HISTORIC PRESERVATION BOARD

AGENDA

HISTORIC PRESERVATION BOARD MEETING

The Historic Preservation Board will hold a remote meeting on Wednesday, July 7, 2021, 5:00 p.m. This meeting will take place using Zoom.

PROPOSED
FLOOR PLANS
A101f

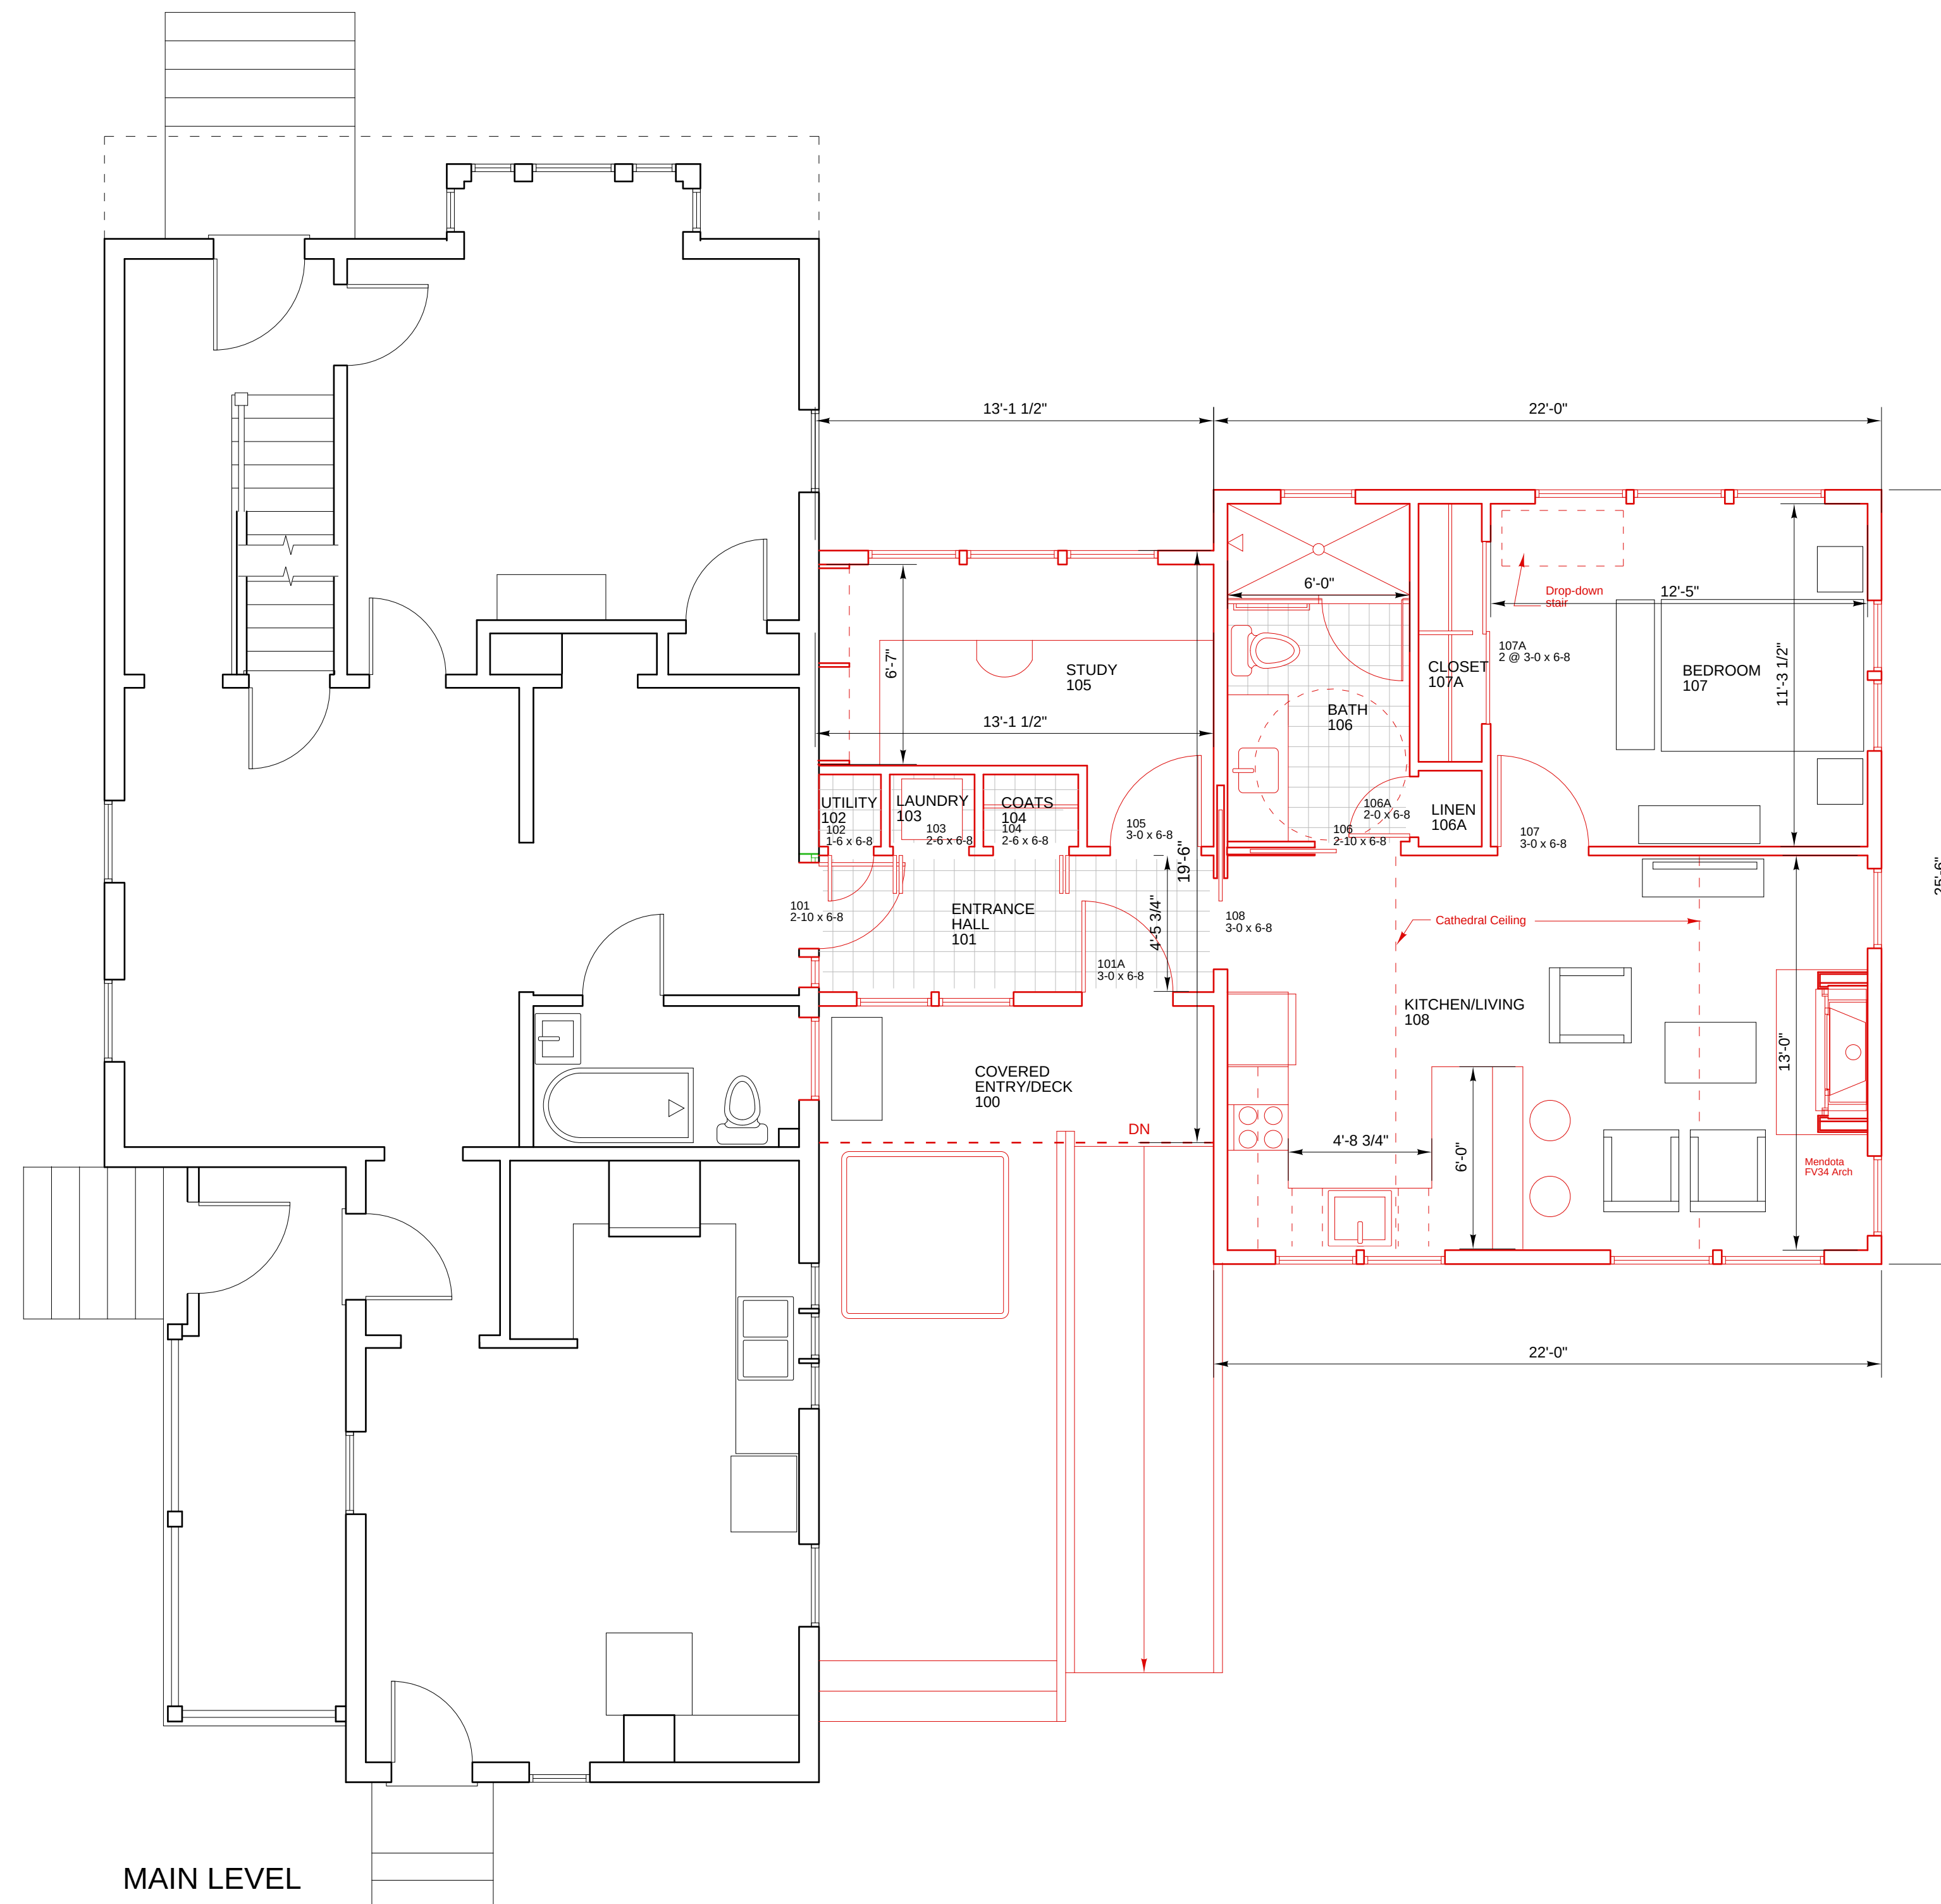
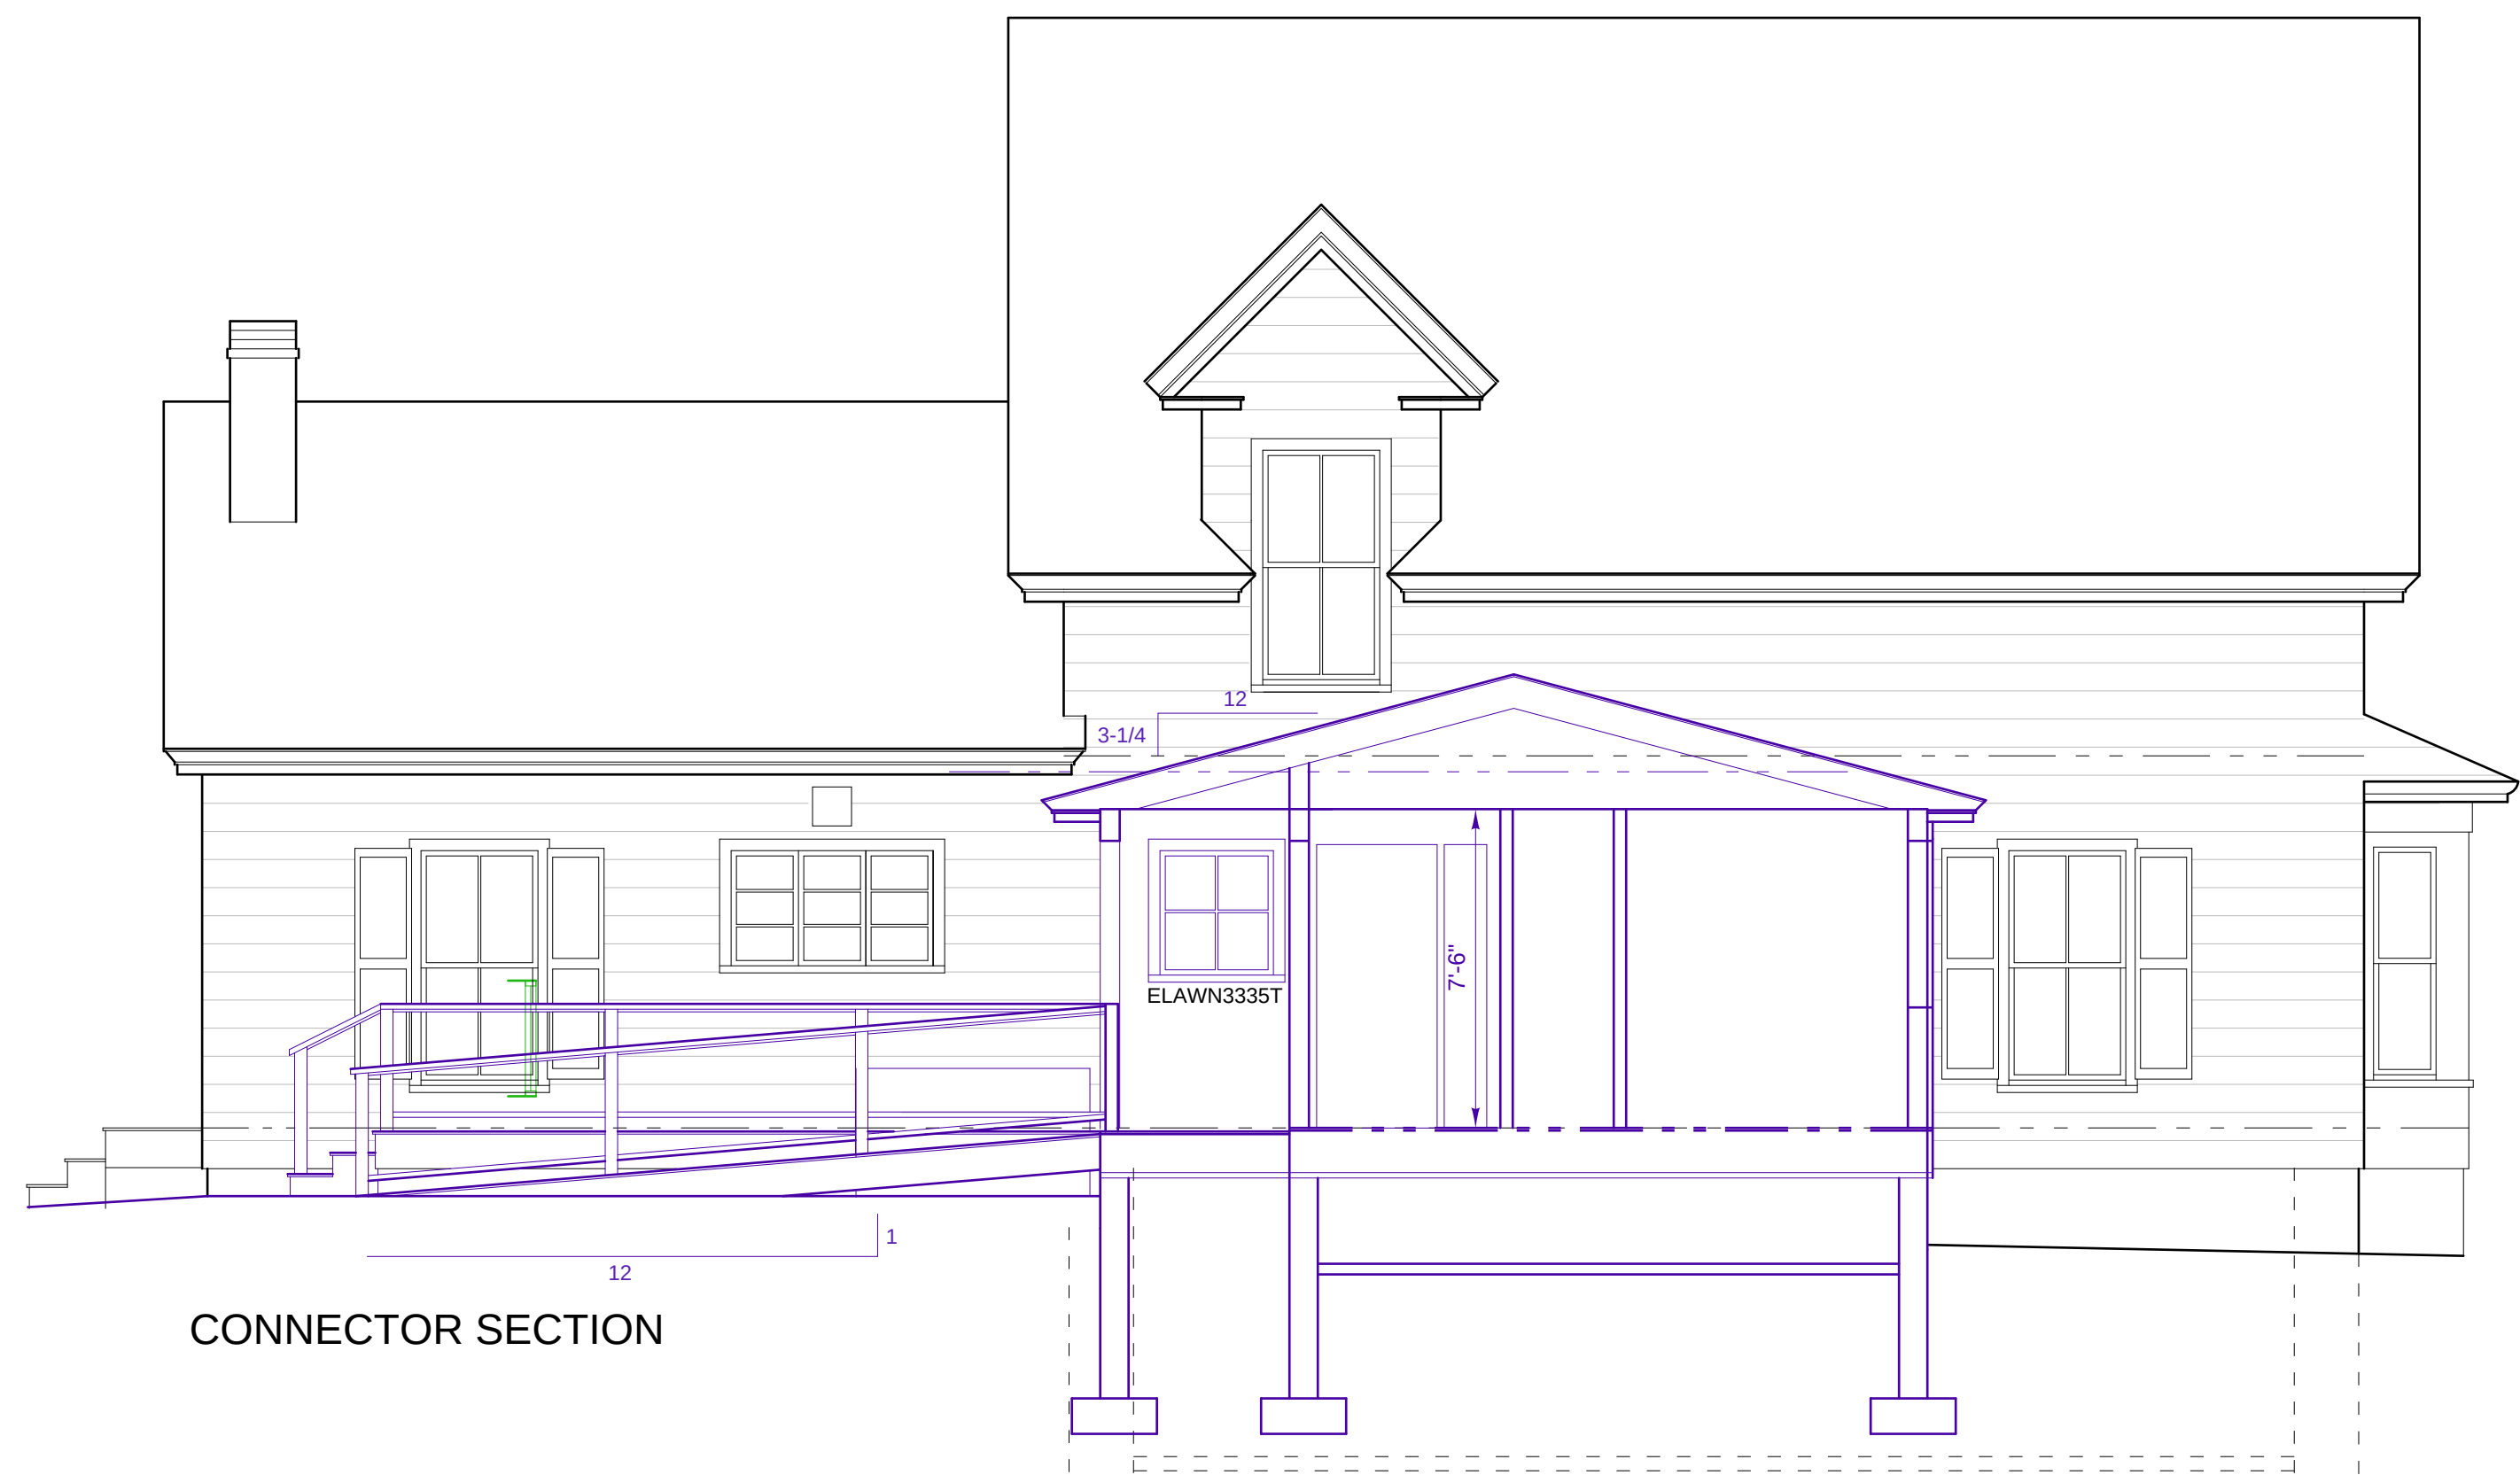
- A gas fireplace in the living room will require venting. The proposed vent has a square, stainless steel, exterior wall cap towards the rear of the east wall. It will be a hot surface during operation, and staff does not know of any plans to paint the cap or whether it is possible to do so effectively and safely.
- A ramp, deck, and rear entry porch are on the back side of the added hyphen, and will most likely be invisible from the street.
- Some concrete foundation will be exposed until the planned foundation plantings will largely obscure it, similar to the treatment of the existing foundation.
- Staff is aware of no other new lighting, vents or mechanical equipment that will be visible.

Though staff believes the proposed design meets the applicable standards, the Board may want to take up a few minor questions for discussion:
